TECH ADVISORY for
SFI Specification 2.2C
Front Engine Dragster Roll Cage; 5.99 Seconds E.T. & Quicker
Effective: January 14, 2011

This tech advisory is meant to supplement SFI Spec 2.2C and does not replace or supersede any other requirements of that spec version, other than what is shown here. Changes are shown in bold/underlined print.

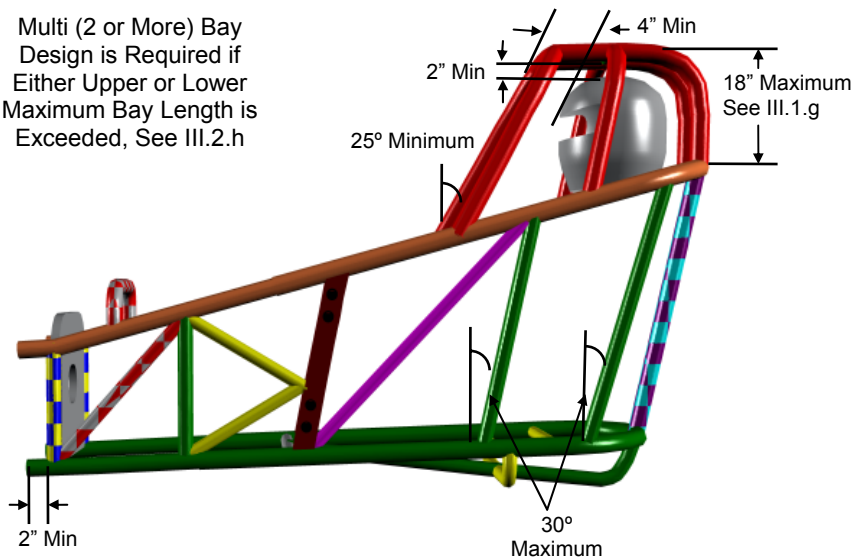
Paragraph III.2.h. The maximum lengths of a bay are 38 inches (96.5cm) as measured along the upper frame rails (#4), and 28 inches (71.1cm) as measured along the lower frame rails (#16 & #17). Bays exceeding any maximum length must be divided by an upright (#21) of 1 1/4" x .058" tubing.

Multi (2 or More) Bay Design is Required if Either Upper or Lower Maximum Bay Length is Exceeded, See III.2.h

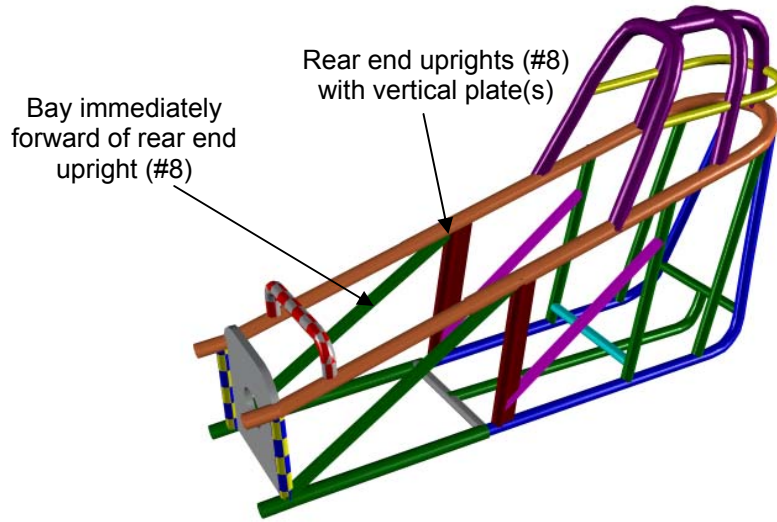
In designs where the rear end uprights (#8) have either single or double welded vertical plates (See Paragraph IV.1.a of Spec 2.2C for plate and welding requirements), the bay immediately forward of the rear end upright (#8) must contain a diagonal (#22) of 1 1/4" x .058" tubing or X's or K's (#23) of 1" x .058" tubing. Diagonals, X's or K's must be partially welded to the rear end uprights. See below example.

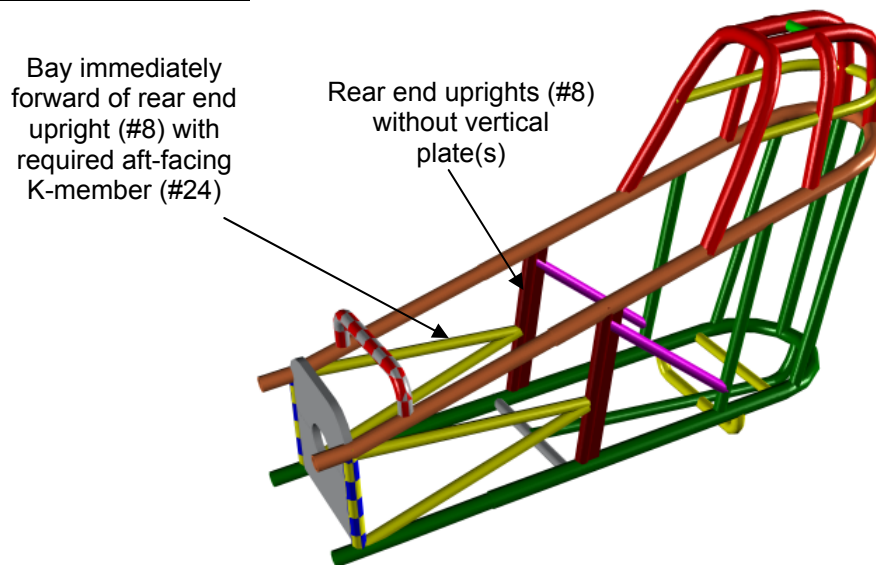
In designs where the rear end uprights (#8) do NOT have vertical plate(s) (See Paragraph IV.1.b), the bay immediately forward of the rear end upright (#8) must contain a 1" x .058" K-member (#24) only, with the point of the K-member facing aft, attached to the rear end upright (#8). A single diagonal or X-member is not acceptable in this bay. See below example.

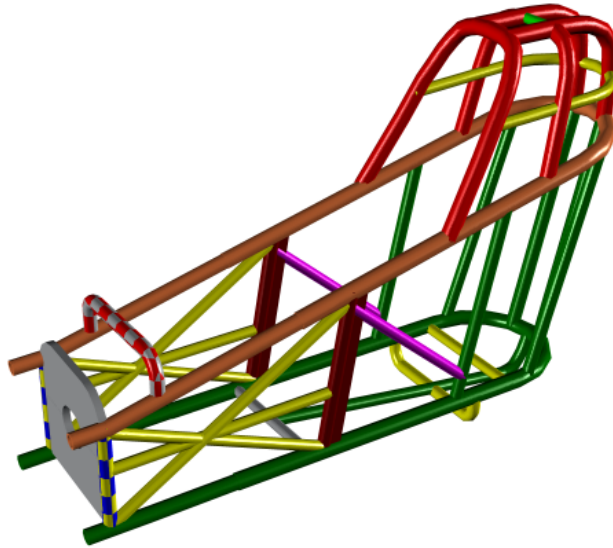
EXISTING cars with a single diagonal (#22) in the bay immediately forward of the rear cross member (#8) may add a secondary diagonal and cross-members of 1"x .058", in lieu of the required K-member (#24). EXISTING cars with an existing X-member (#23) in the bay immediately forward of the rear cross member (#8) may add cross-members of 1"x .058" in lieu of the required K-member (#24). See below example.

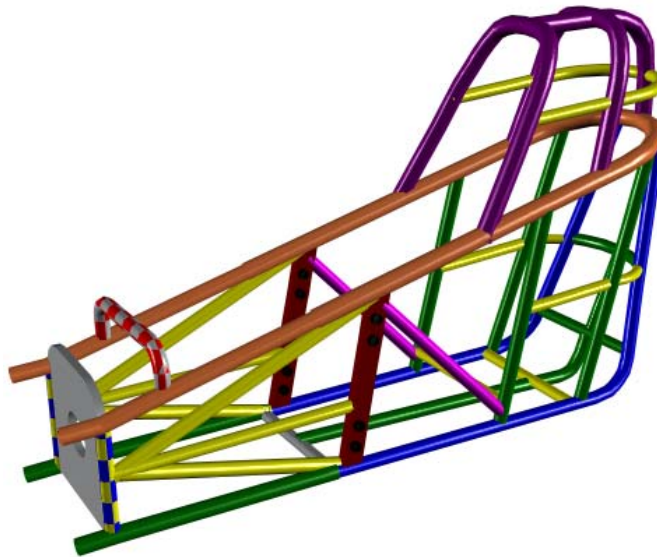
EXISTING cars with a K-member (#23) in which the point faces forward in the bay immediately forward of the rear cross member (#8) may add a cross-member of 1"x .058", in lieu of the required aft-facing K-member (#24). See below example.
